AGENDA ITEM 4A

Replat—Centech Business Park Replat Six—

**CITY OF LA VISTA
PLANNING DIVISION
RECOMMENDATION REPORT**

RE: Replat – Centech Business Park Replat 6 – Initial Review Letter

CITY OF LA VISTA
FINAL PLAT

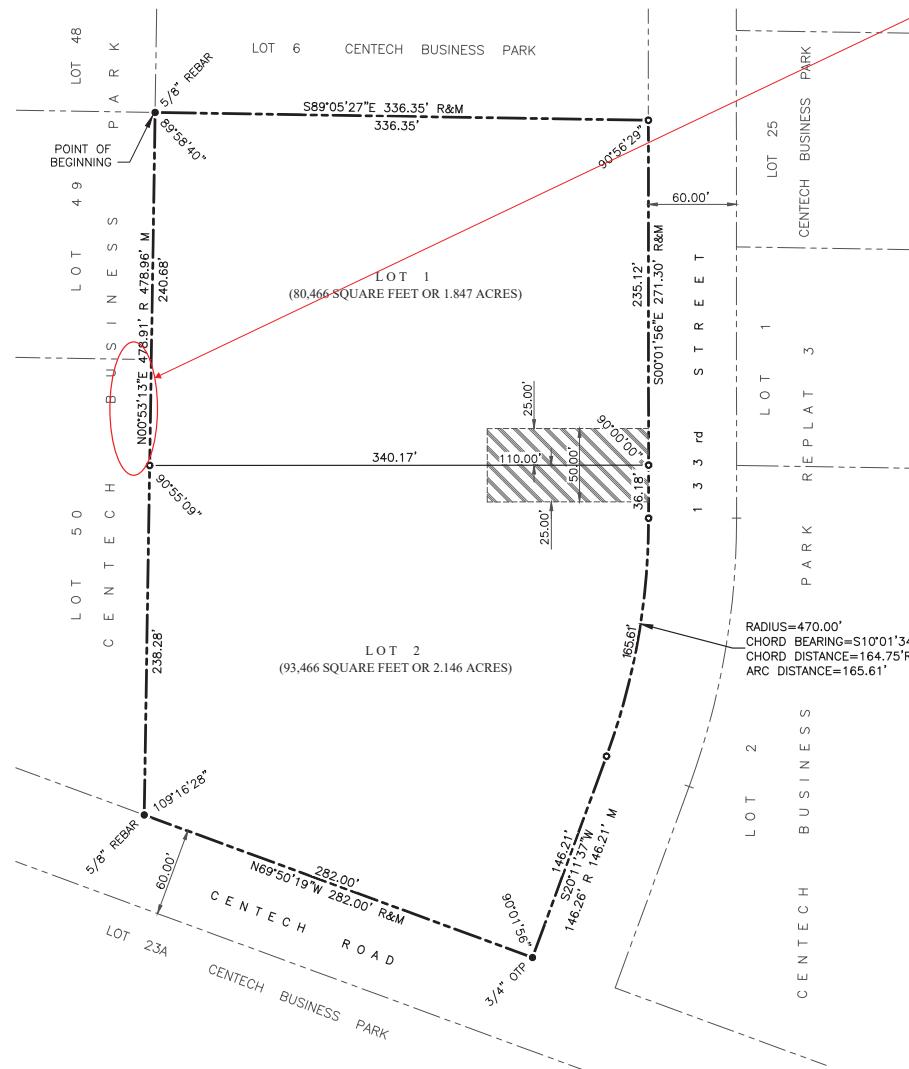
14. Please revise the City approval block (Section 10.04) and the Sarpy County Public Works approval block, as this is no longer an administrative plat.

17. The name "Centech Business Park Replat Four" has already been used on a recorded administrative plat. The name "Centech Business Park Replat Five" is also already being used in an existing administrative plat application which is set to be approved prior to your application. Please use the name "Centech Business Park Replat Six."

18. Please find attached a redlined version of the plat from Sarpy County Public Works noting an error in the bearing on the west property line. Please ensure that the bearing and legal description match.

Updated on the final plat.

The preliminary and final plat have been updated to "Centech Business Park Replat Six".

This has been updated on the final plat.
